# Access Compliance Report

## Public Rights-of-Way

Intersection ID: 15632	Main Street: EXECUTIVE_CENTER_DR	Cross Street: FARM_POND_LN	Location: SW
ADA ID: FEB73F83D2F4	Ramp Type: BlendTrans2	Initial Pass/Fail: Fail	Overall Compliance: No
		Severity Score: 10

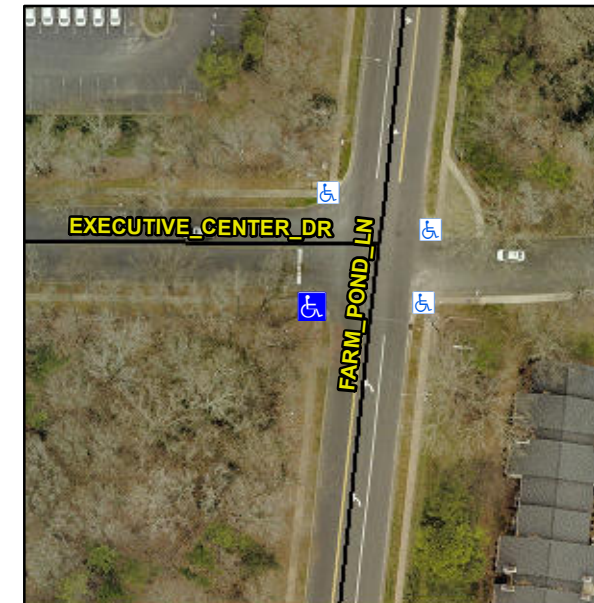
**Not Found, R304.5.1, R304.5.3**

Compliance	Description	Data	Compliance	Description	Data
N/A	Ramp Length (in)	62.0	Yes	BlendTrans Slope (%)	1.9
No	Ramp Width (in)	47.0	No	BlendTrans XSlope (%)	2.4
N/A	Flare Type LT	N/A	N/A	Flare Type RT	N/A
N/A	Flare Slope LT (%)	N/A	N/A	Flare Slope RT (%)	N/A
N/A	Flare Traversable LT?	N/A	N/A	Flare Traversable RT?	N/A
N/A	Landing Length (in)	N/A	N/A	DWS Provided?	N/A
N/A	Landing Width (in)	N/A	N/A	DWS Contrast?	N/A
N/A	Landing Slope (%)	N/A	N/A	DWS Length (in)	N/A
N/A	Landing X Slope (%)	N/A	N/A	DWS Full Width?	N/A
N/A	Landing Curb? (Y/N)	N/A	N/A	DWS Offset (in)	N/A
N/A	Shared Landing?	N/A			
N/A	Gutter Ponding?	N/A	N/A	Gutter Slope (%)	N/A
N/A	Gutter Lip Ht (in)	N/A	N/A	Gutter X Slope (%)	N/A
N/A	Painted X Walk1?	No	N/A	Painted X Walk2?	No
	X Walk 1 Direction	To E		X Walk 2 Direction	To N
	X Walk 1 Width (in)	N/A		X Walk 2 Width (in)	N/A
	X Walk 1 Slope (%)	4.5		X Walk 2 Slope (%)	1.1
	X Walk 1 X Slope (%)	0.2		X Walk 2 X Slope (%)	3.9

N/A	Ramp inside XWalk1?	N/A	N/A	Ramp inside XWalk2?	N/A
	Road Slope (%)	2.6		Clear Space?	N/A
	Road X Slope (%)	3.8	N/A	Clear Space to XWalk (in)	N/A
N/A	Any Obstructions?	N/A	N/A	Storm Grate/Utility Hazard?	N/A
	Obstruction Type			Storm Grate/Utility Type	
		N/A			N/A
			Yes	Surface Condition? (G/P)	Good
			No	Curb Slope (%)	12.5

**Remove & Replace Curb Ramp With Two New Directional Ramps or Equivalent.**
